# ACCESS PERMIT APPLICATION

Permit # AL2022-03

Application Date: 11/29/22 Physical Address of Property: 65 HIGHLAND DRIVE, RICHMOND

Description of Project: CURB CUT UP HIGHWAY EXISTING TO BE USED property in floodplain? \_\_\_\_\_

Sketch Plan

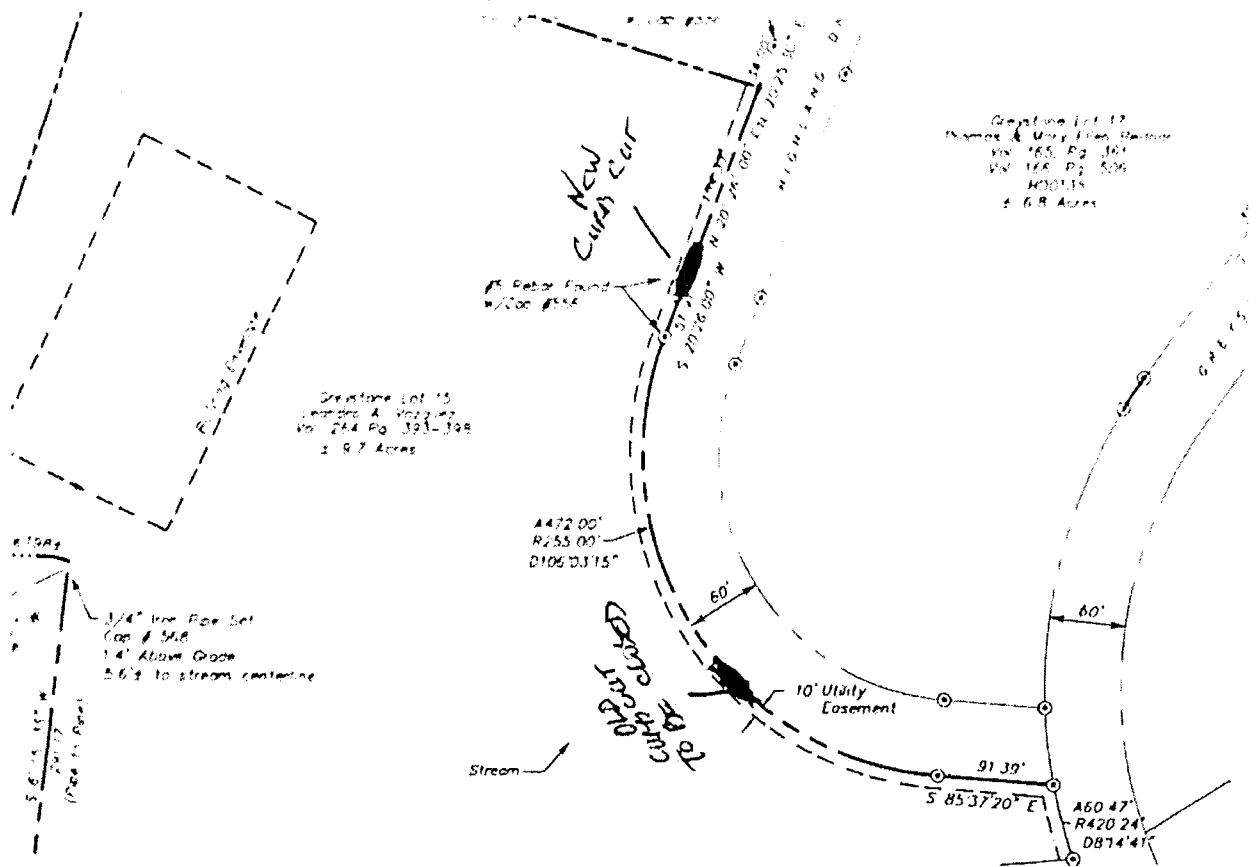
Comments: INSTALL 18" x 30' HOPE CULVERT IN LOW POINT OF DITCH Additional comments on reverse

Highway Department Comments: SIGHT LINES ARE GOOD IN BOTH DIRECTIONS. EXTRA ATTENTION NEEDED FOR EROSION CONTROL AS THIS DRIVE IS A HILL SIDE CURVE.
